1990 Corvette: Service Bulletin: Information on Door Lock System Components and Replacement Components

Subject: INFORMATION ON DOOR LOCK SYSTEM COMPONENTS AND REPLACEMENT COMPONENTS

Model and Year: 1990 CORVETTE

Bulletin Number: 90-375-10 - (10/25/1990)

Figure 1

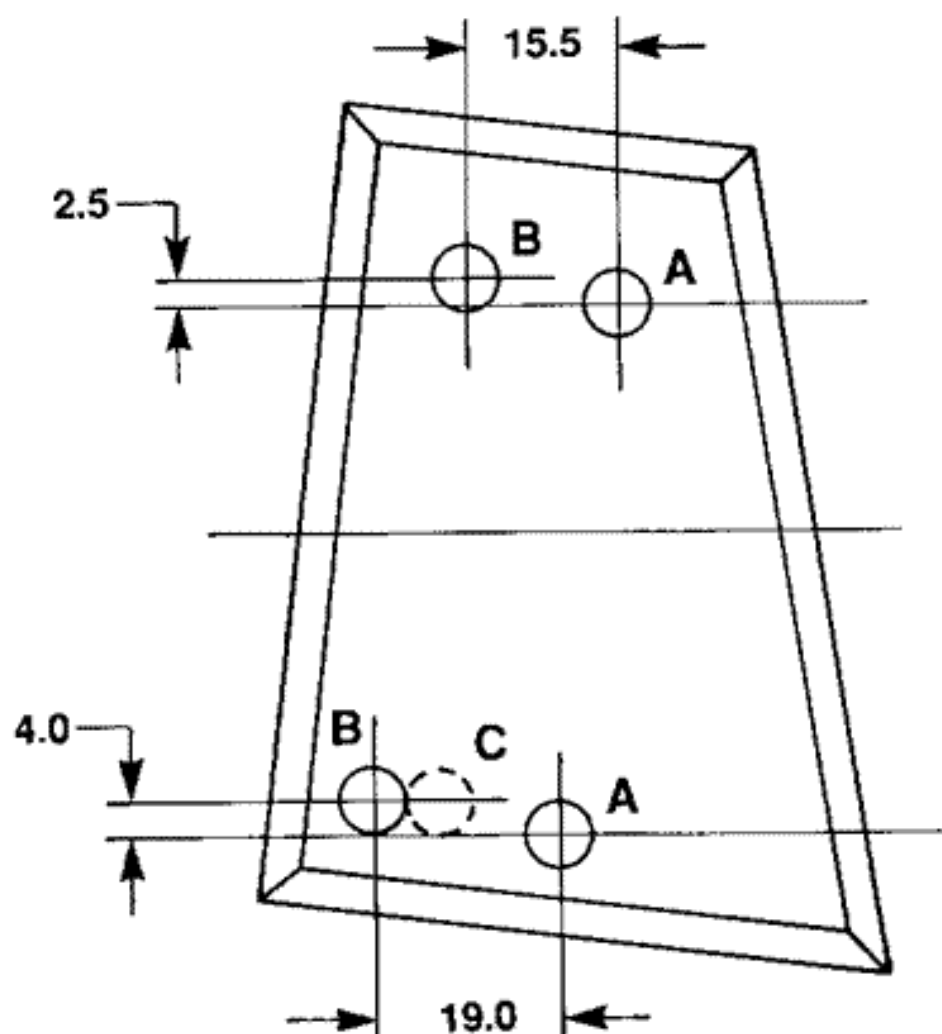
In addition to replacing the above components, it may be necessary to relocate the power door lock actuator on the door inner panel. Figure 1 will illustrate the hole patterns.

- If the actuator is located in the holes marked "A," it will not need to be relocated.
- If the actuator is located in the holes marked "B";
- remove the actuator by drilling out the attaching rivets.
- locate the new attaching holes ("A") using the dimensions on the illustration.
- attach the actuator in the new location using 1/4" X 1/2" peel type rivets.

IMPORTANT: Hole "C" may or may not be present. Relocate holes from "B" locations only.
